REMARKS

Annotated Marked-up Drawing

Fig. 10

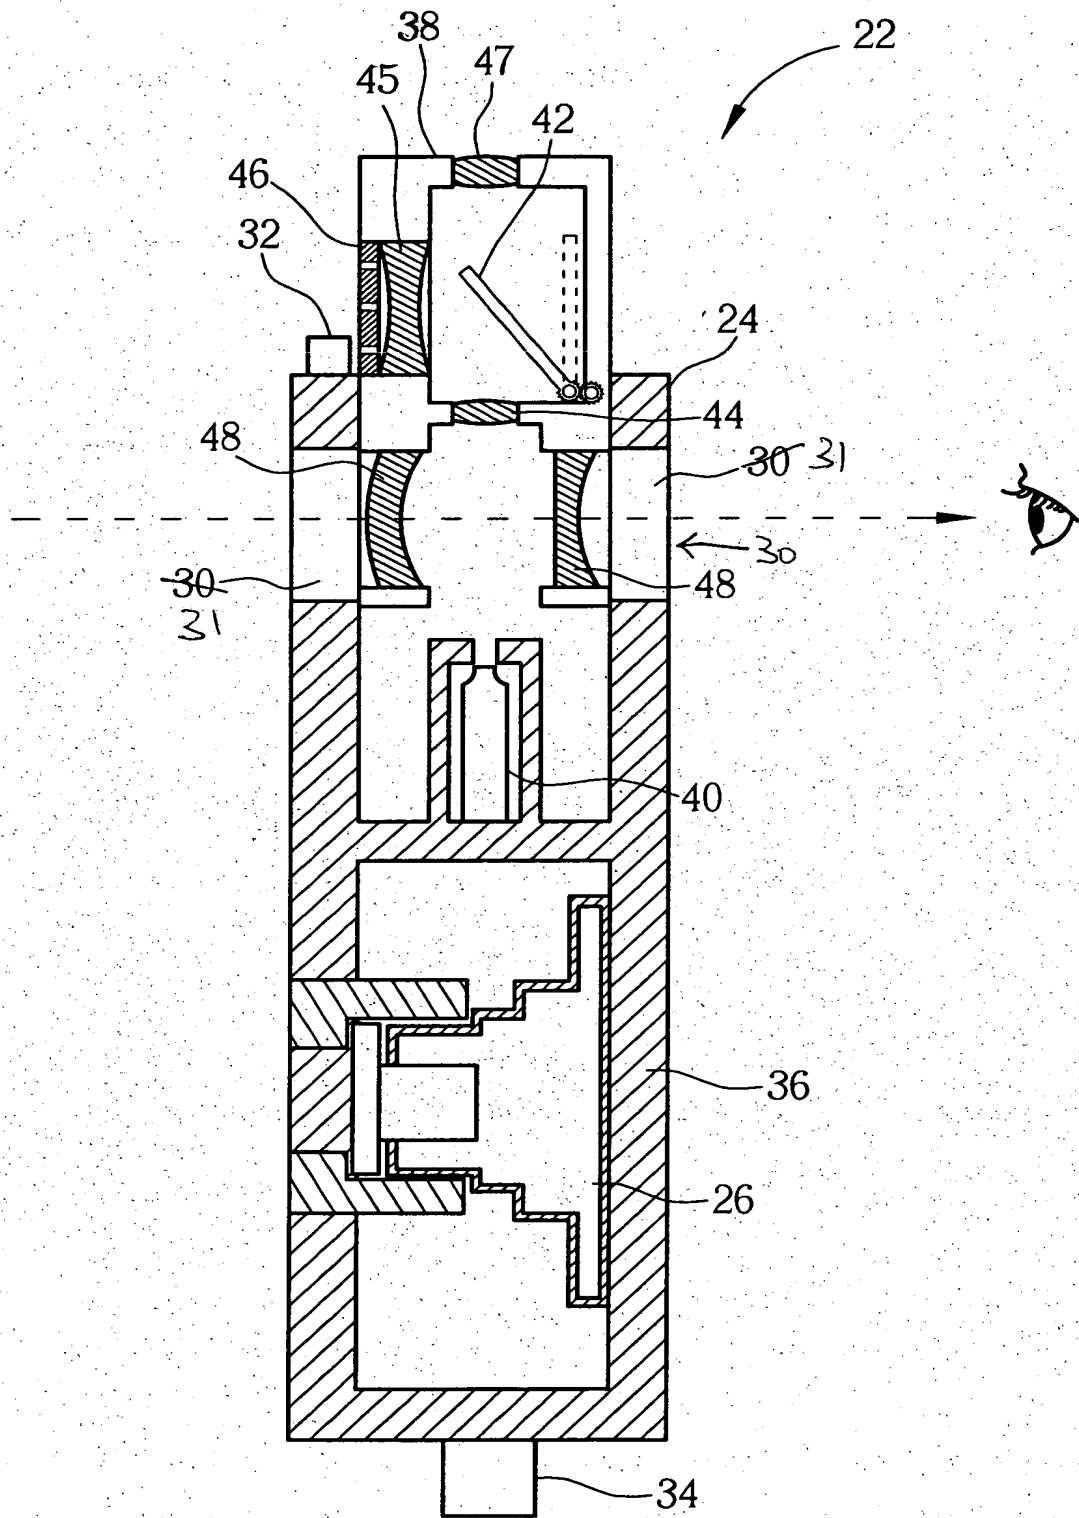
20 In paragraphs [0024], [0027], [0029], and [0032] "two optical viewfinders 30" is corrected to "optical viewfinder 30". For further clarification, these paragraphs are further amended to recite that the single optical viewfinder 30 comprises two ports 31, which are the illustrated holes in Figs.6, 10, and 12. The applicant believes that all instances of this error are corrected.

Figs.6, 10, and 12 are amended to correctly illustrate the reference numeral 30 for the optical viewfinder and the numeral
10 31 for the two ports for consistency with the amended specification. Replacement sheets and annotated marked-up drawings are provided for these figures.
